General Plan/LCP Implementation Committee

February 18, 2009

Item 2A - Development on Bluffs and Canyons

Eaton Comments – responses in *bold italics*

Draft Zoning Code Bluff and Canyon Properties

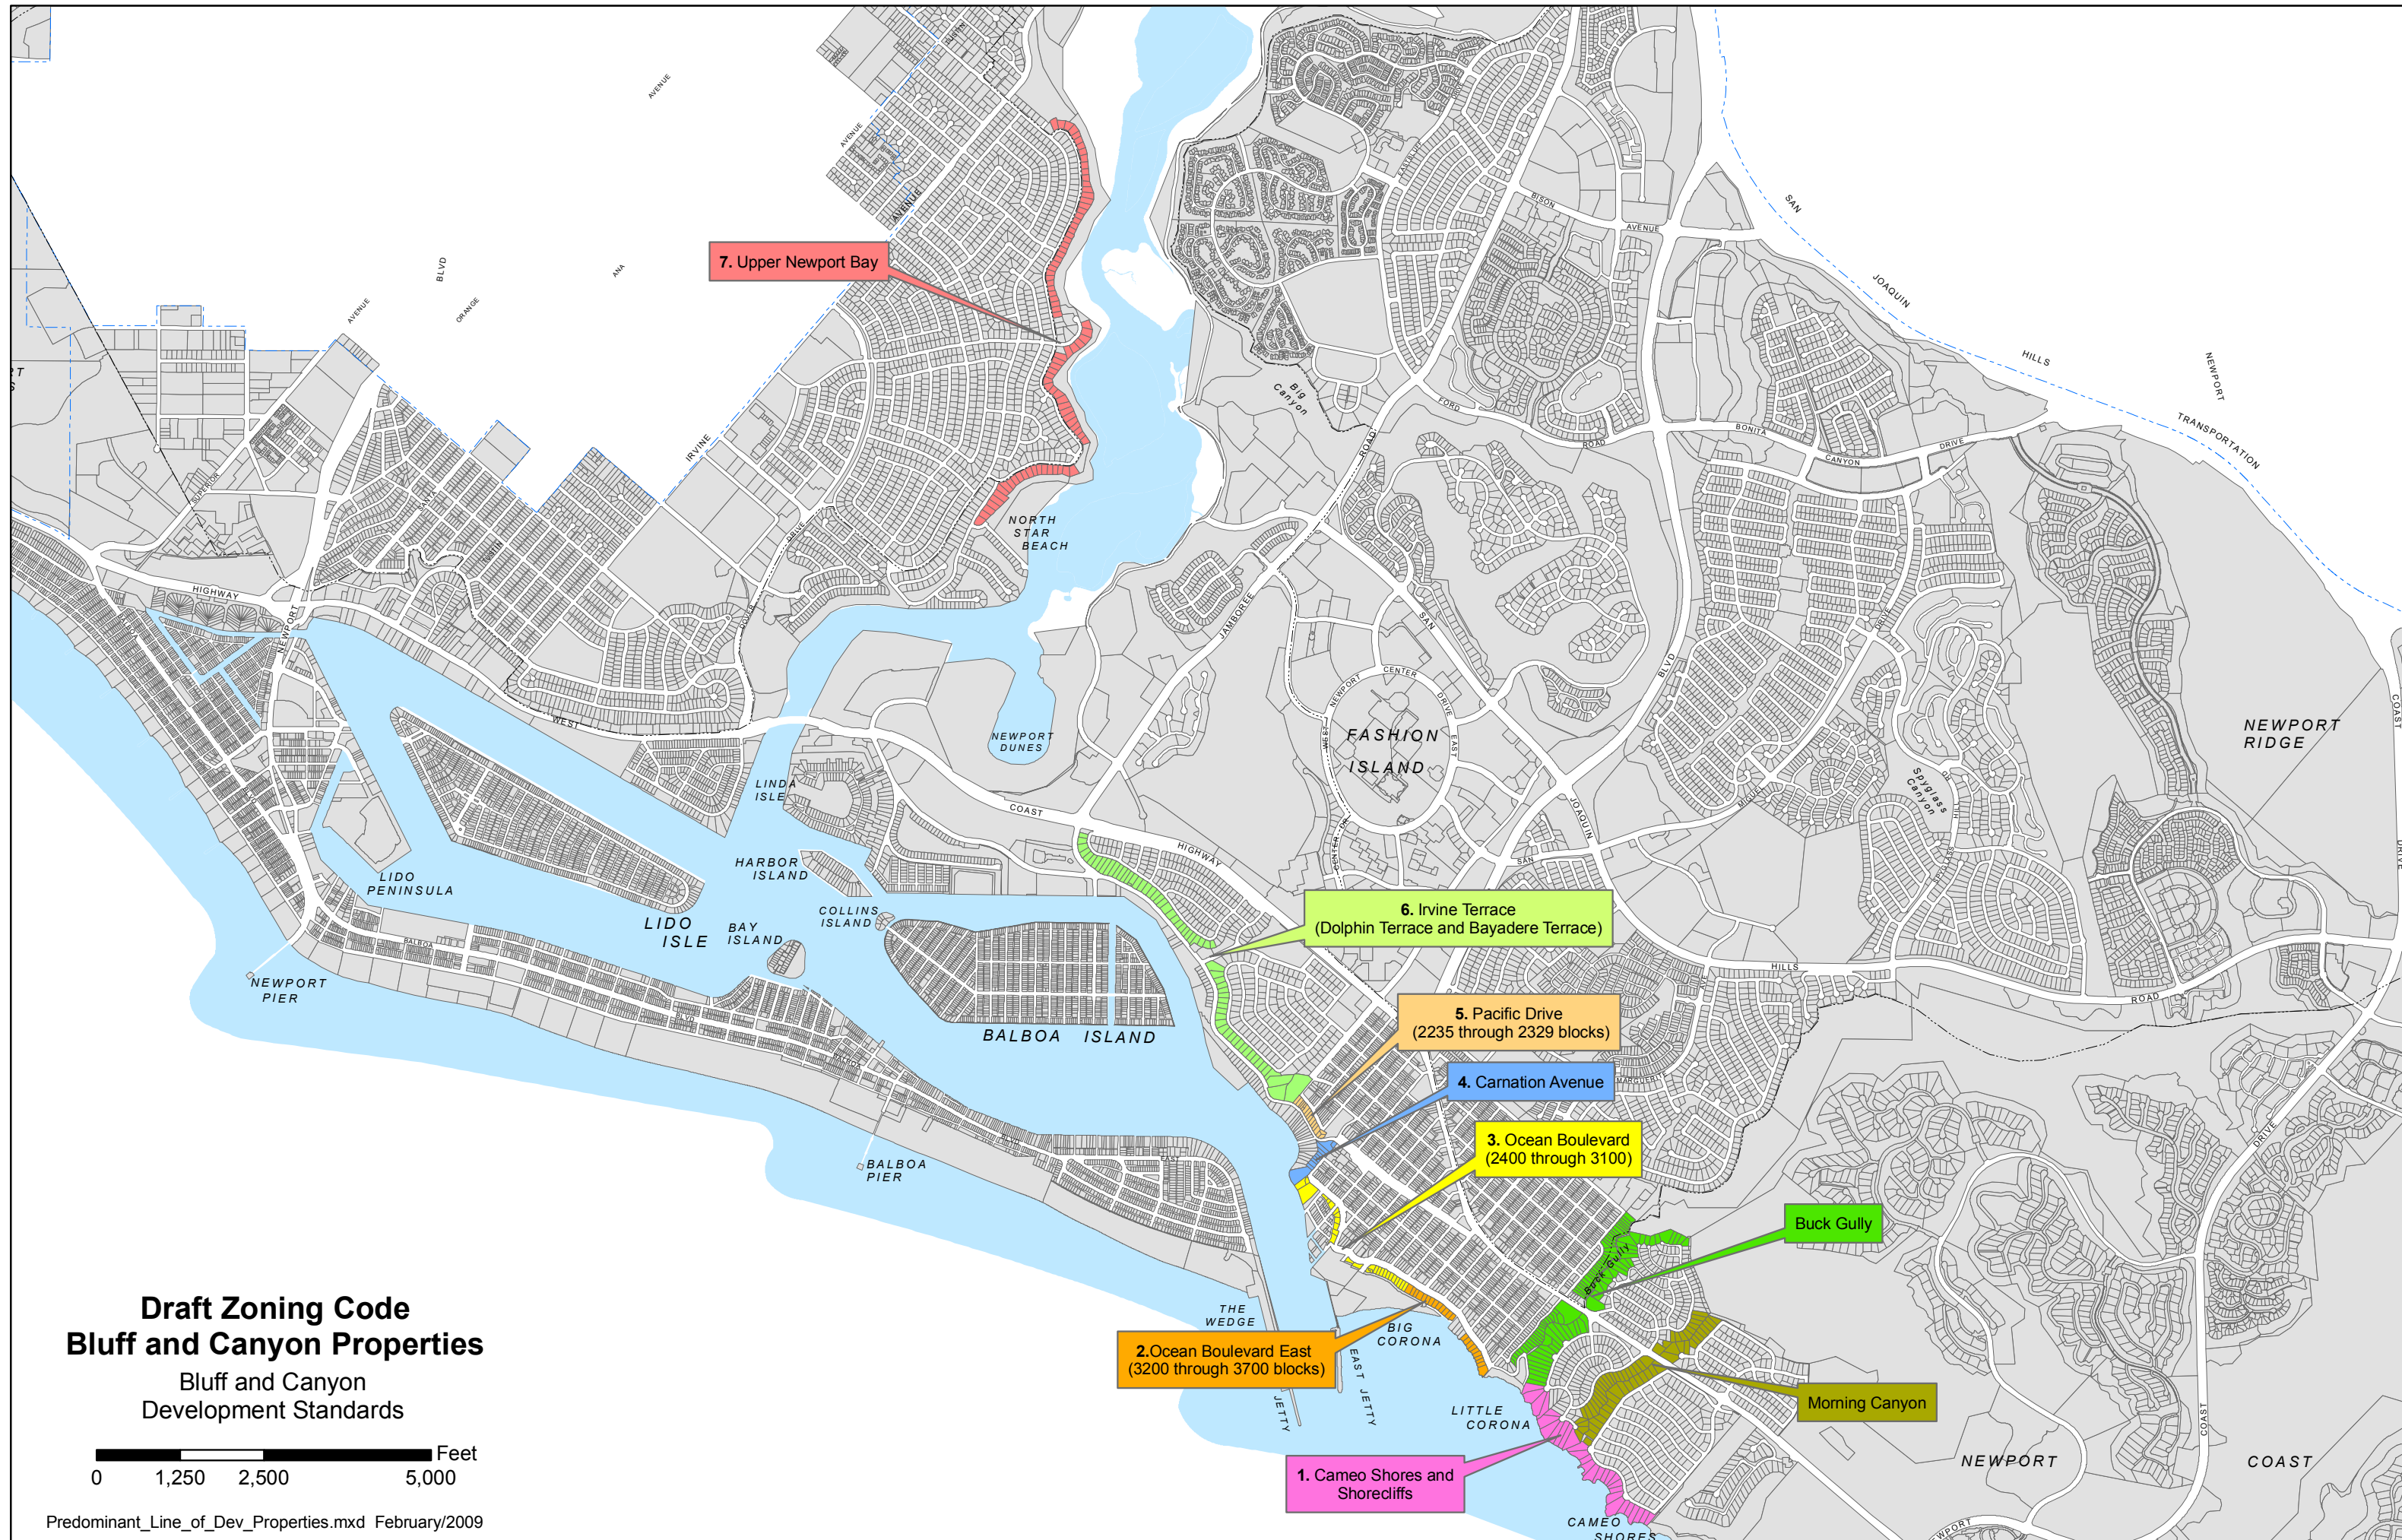
179) The first Subsection A. (hand numbered page 8) refers to the "Predominant Line of Development Map". The only map attached for this topic is a new "Bluff and Canyon Properties" Map. Is this what subsection A is intending to refer to?

Response: Yes, but we will change the reference to the "Bluff and Canyon Properties" Map.

Figure 3-xx
Construction Development Limit Along Canyon Face

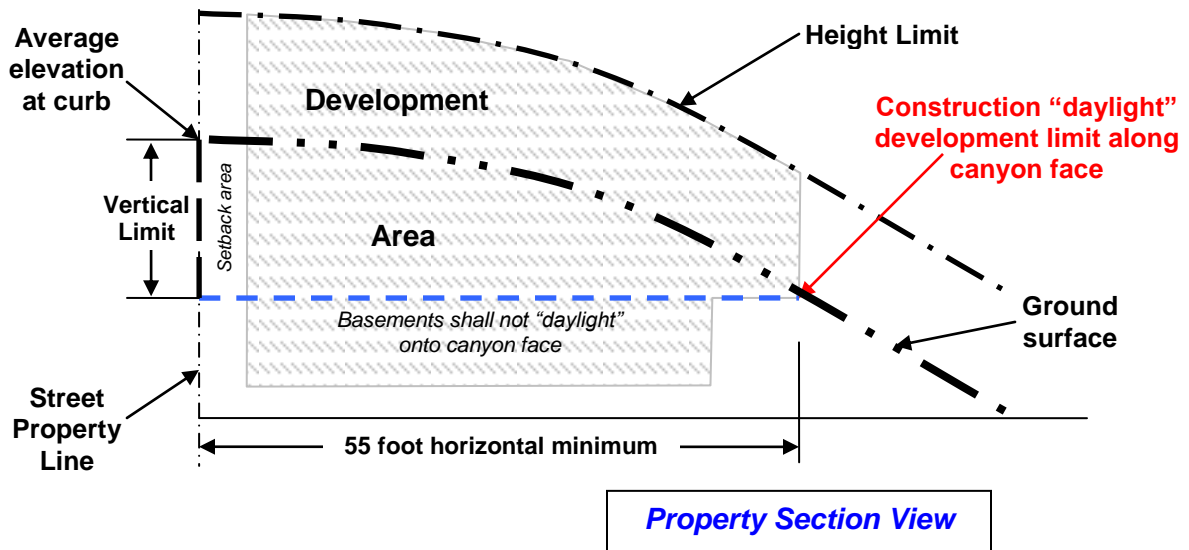
PQ: Why multiple references to the same line? Please explain and identify the footage for the vertical line.

Response: We can simplify
